SPEATH ENGINEERING

RE: Port Pheonix Water Way Marina – DCI2023-00054 – Major PD

Please find below responses and commentary to the provided comments from staff in your September 10, 2024 letter regarding the Commercial Planned Development Application for Port Pheonix Water Way Marina (DCI2023-00054).

AUTOTURN INLET DR. EXHIBIT SHT. 1
FOR
WATERWAY MARINA
SAFE HARBOR MARINAS
LEE COUNTY, FLORIDA

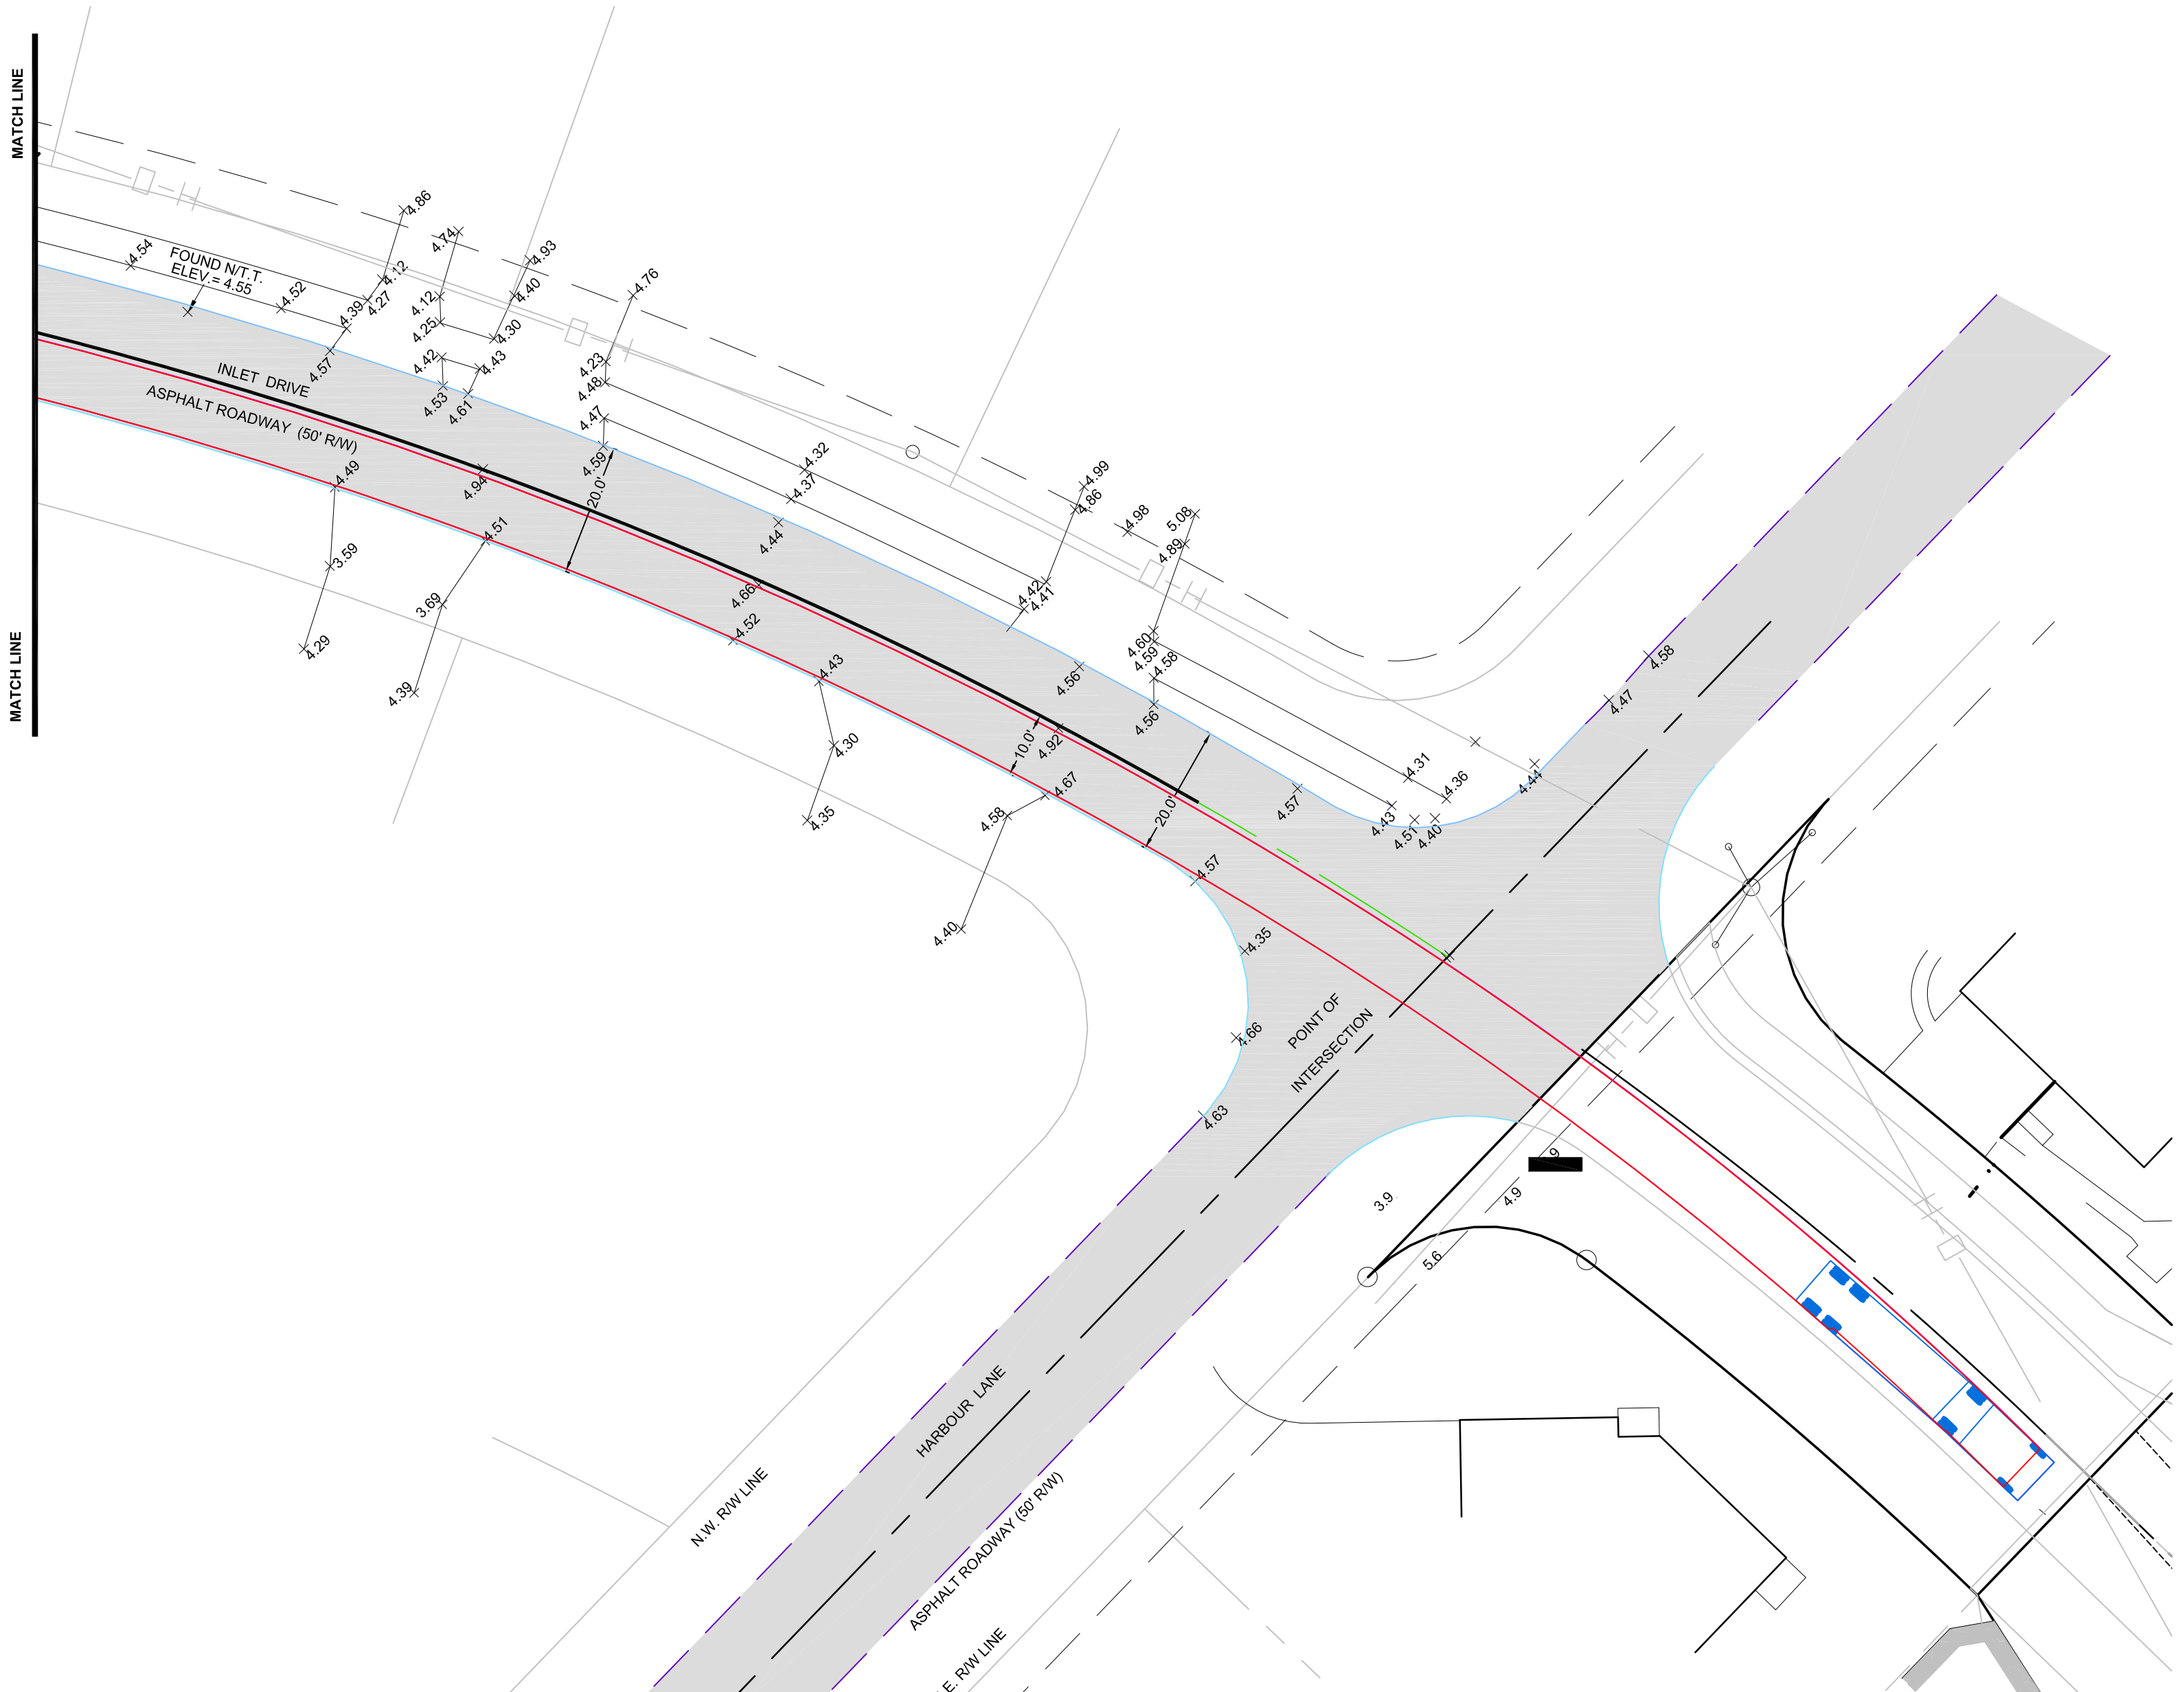
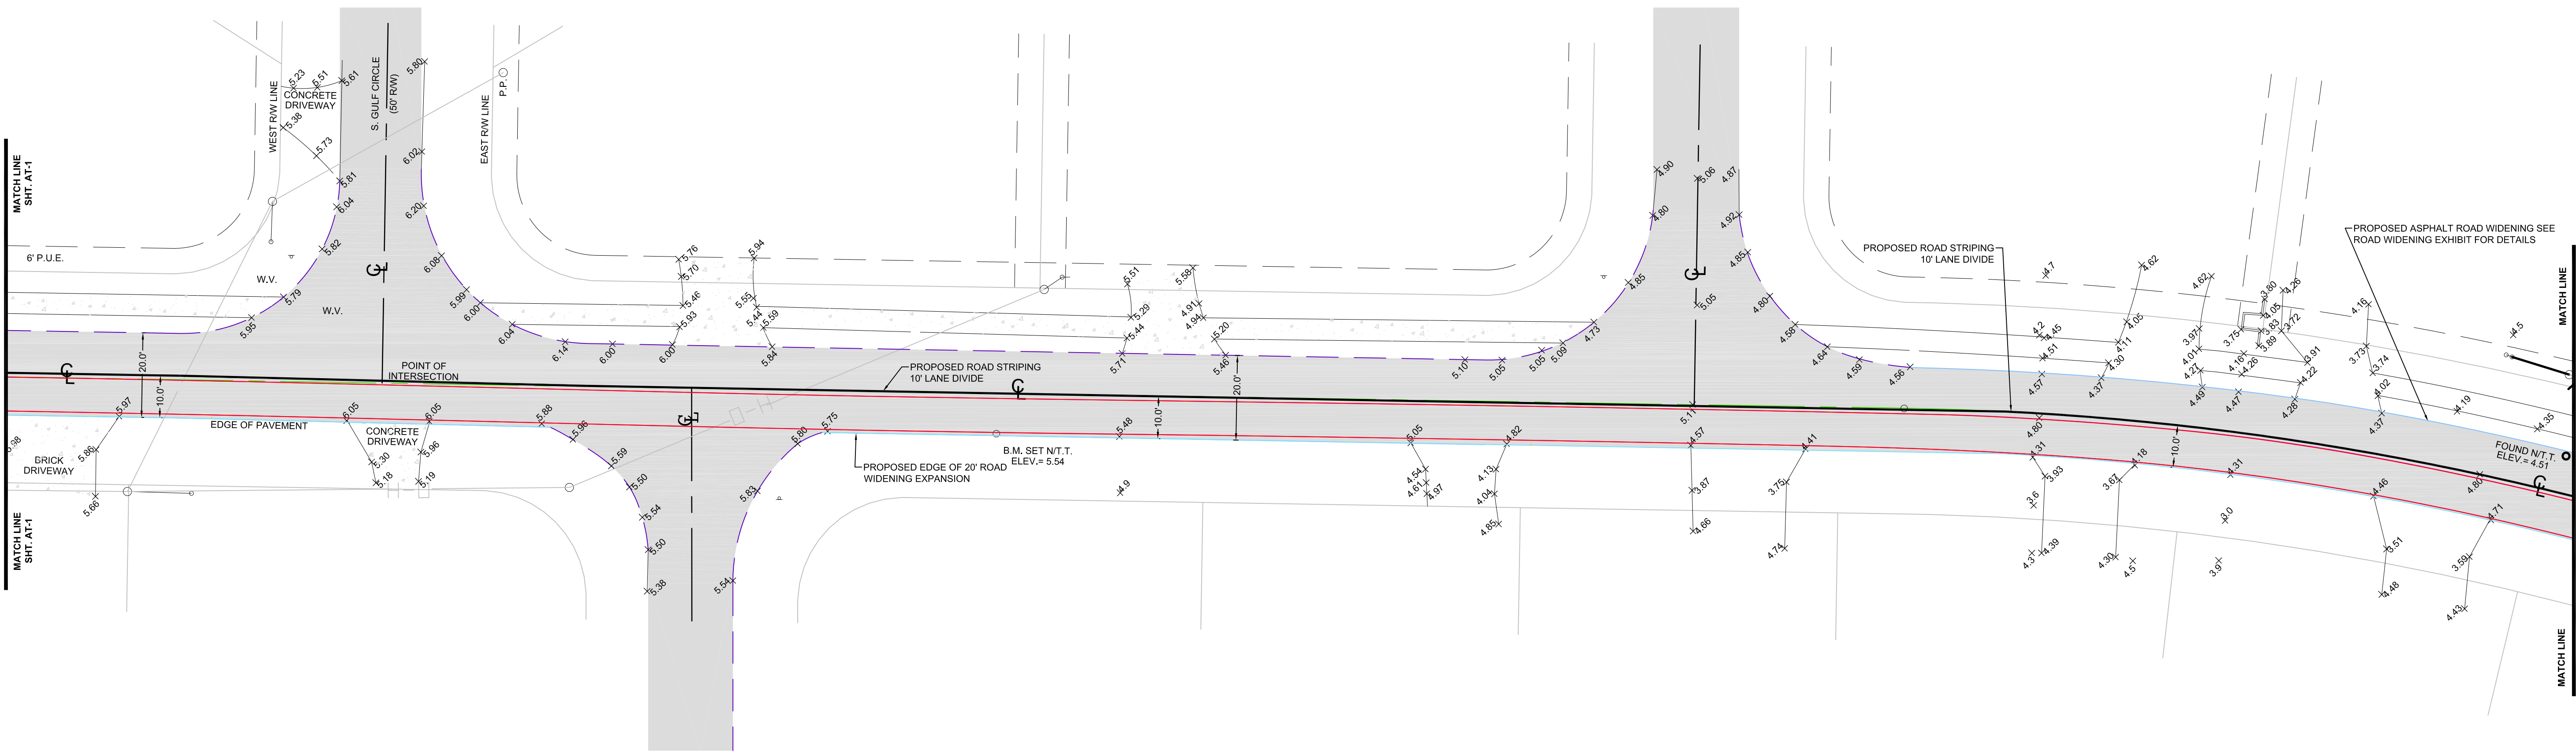
1. *Please provide additional information/justifications to demonstrate that the proposal to remain the 20-ft lane width will be able to accommodate all anticipated vehicles, including commercial trucks without any adverse impacts to the Inlet Dr right-of-way.*

2. *Please provide plan(s), sealed by a registered professional engineer, that accurately reflect the applicant's alternative proposal for the Inlet Dr right-of-way. The requested plan must show and specify typical cross section(s) for the proposed and existing improvements to the Inlet Dr right-of-way with information on dimensions, elevations, cross and side slopes and related information/specifications in comparison with the street design and construction standards for a suburban local street in LDC Section 10-296.*

Per our discussion, full roadway plans will be provided at time of Development Order processing, however the attached Autoturn exhibit shows the limit of the proposed 10' lanes (20' total road width) in the configuration proposed for Inlet Drive.

CROSS SECTION A-A

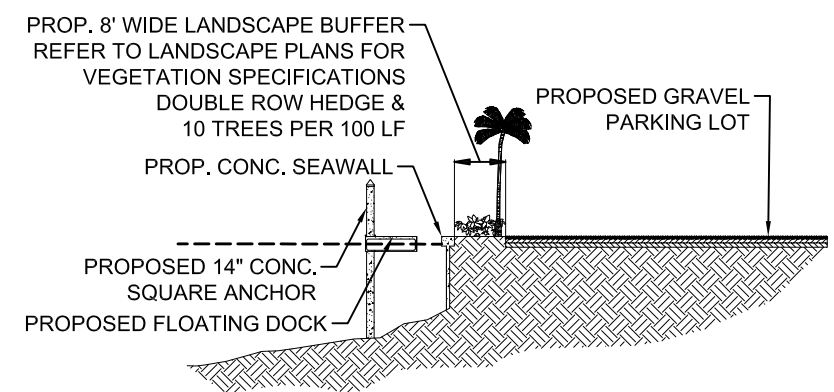
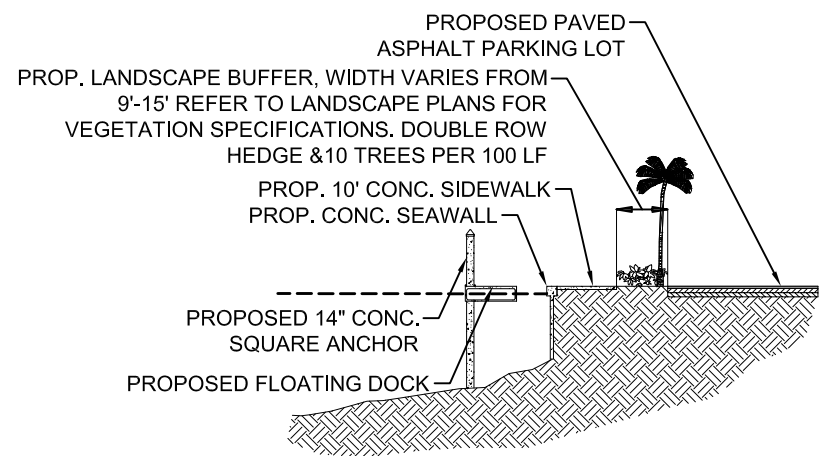
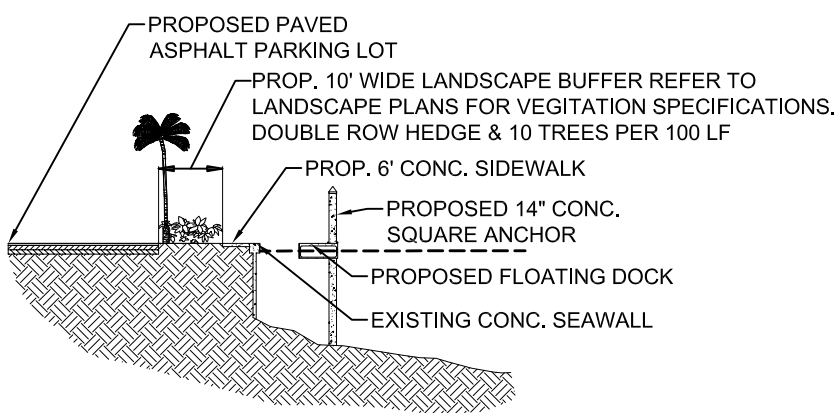
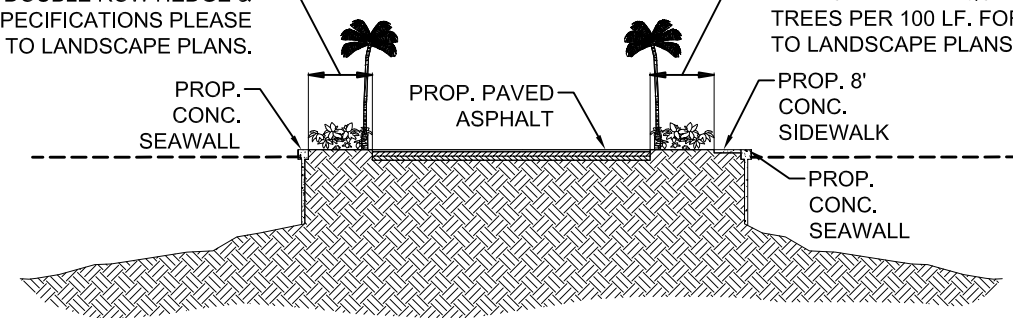
4. *Cross sections for particular property lines have been provided. Revise to provide cross sections for each area that the applicant is requesting a deviation from to provide details to demonstrate compatibility.*

Applicable cross sections have been added and revised in the landscape exhibit accordingly. Additionally, we have delineated the individual deviations correlating to each proposed buffer where it is applicable.
